OREGON FUEL INJECTION, INC.

73TRTK Return Line Kit Installation

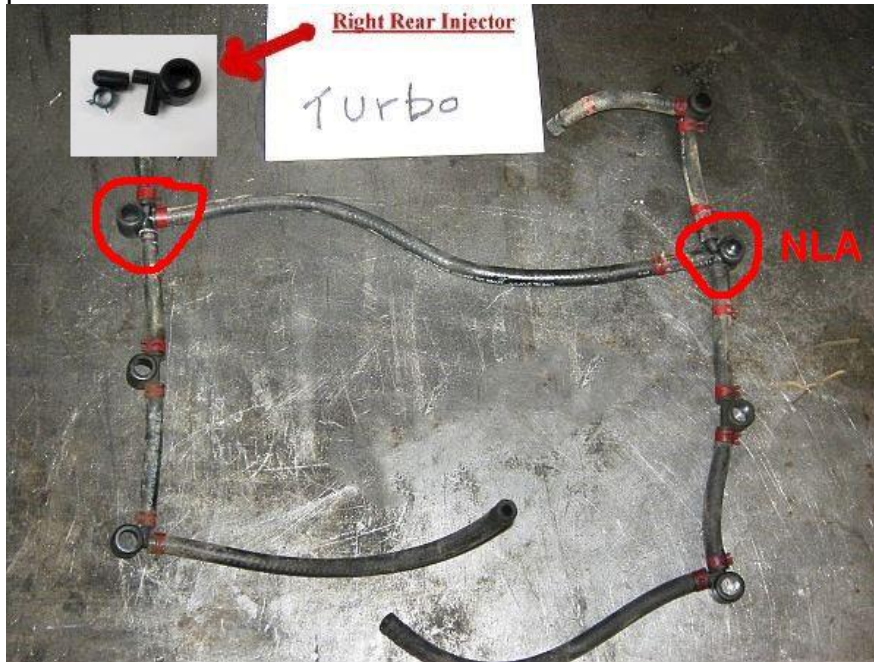
The picture is of old used parts and only used to illustrate the changes to the right rear injector return connection. Also note that the 3-way tees, that are the third ones back on each bank are no longer available. They will be replaced with plastic tees installed in the return line on each side.

The original right rear injector return line tee is no longer available. In this kit we have substituted a double return tee, with a plug and clamp.

1. Install the silicone plug on the unused port and install the single green clamp on the plug.
2. The red clamps are for installation on the 1/4 inch hose.
3. Assemble the remainder of the return tees and hoses like it was originally.
